**TOWN OF CARMEL
PLANNING BOARD**

**PLANNING BOARD AGENDA
NOVEMBER 12, 2020 – 7:00 P.M.**

Re: Zakon Site Plan
Mike Carnazza 10/21/20 Comments

Re: Zakon Site Plan
Rich Franzetti 10/17/20 Comments

SCALE 1" = 20'	DRAWN BY BJW	DRAWING NO. C-5 5 of 9
DATE 01-25-20	CHECKED BY MAD

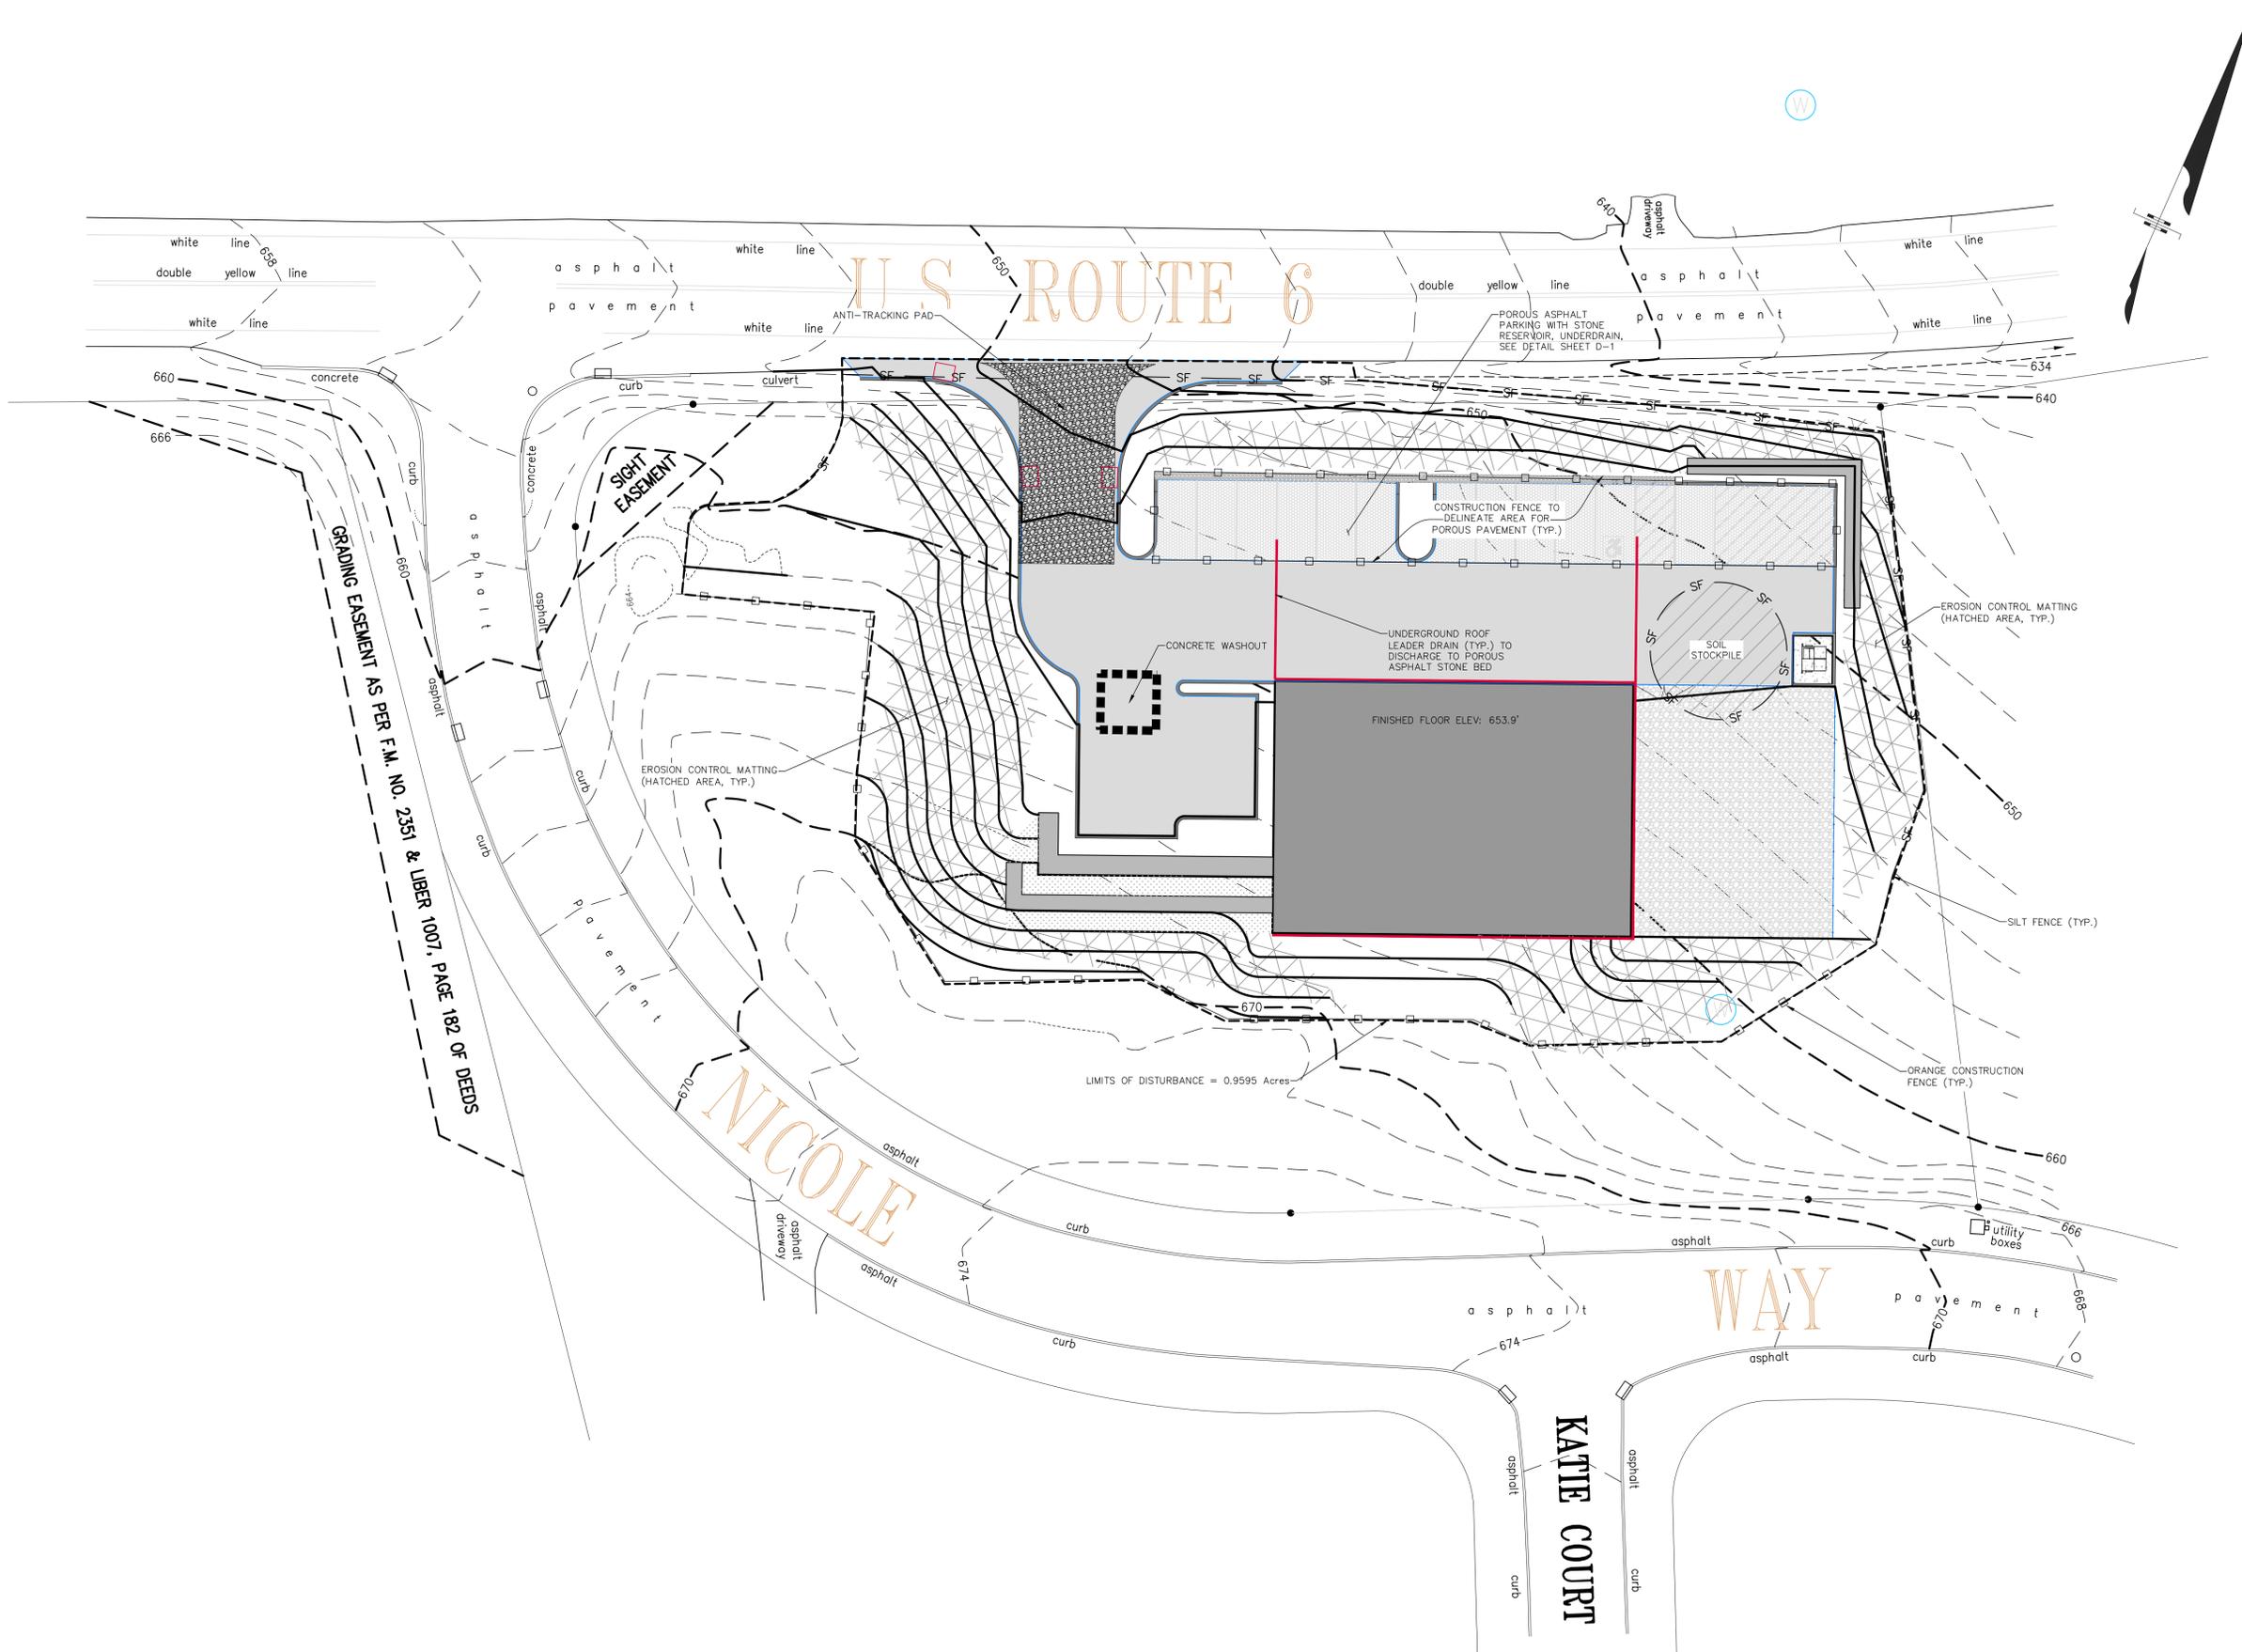
6. Sheets C-5, D-4:
 - a. Porous pavement now indicated on the plan.
 - b. Details for protection of the porous pavement is now indicated on the plans.
 - c. The proposed pavement is in general conformance with Chapter 5.3.11 of the NYSDEC Stormwater design manual. The primary function of the asphalt will be to act as a collection and detention structure to maintain water discharge from the finished site to pre-construction level with infiltration being a desirable secondary benefit. The depths of stone and location of underdrain reflect this.

Site Details		
SCALE N.T.S.	DRAWN BY BJW	DRAWING NO. D-1
DATE 01-25-20	CHECKED BY MAD	6 of 9

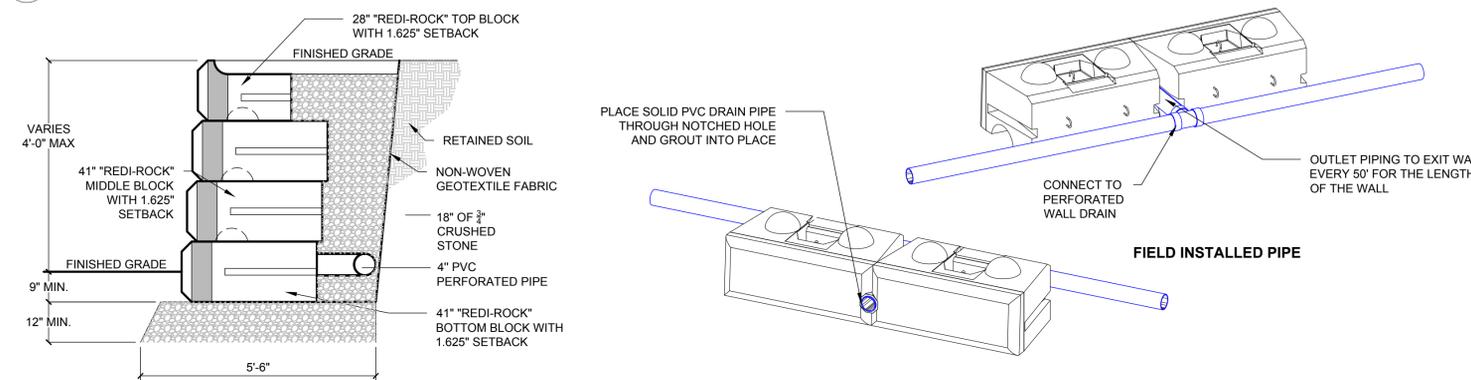
1. The retaining wall heights are now noted on all of the plans although the heights were and are on Sheet D-1.
2. Although floor plans and elevations were presented at the last Planning Board meeting, we have attached, as part of our submission, floor plans and elevations.
3. The lot depth and lot width lines are now shown on the plan.
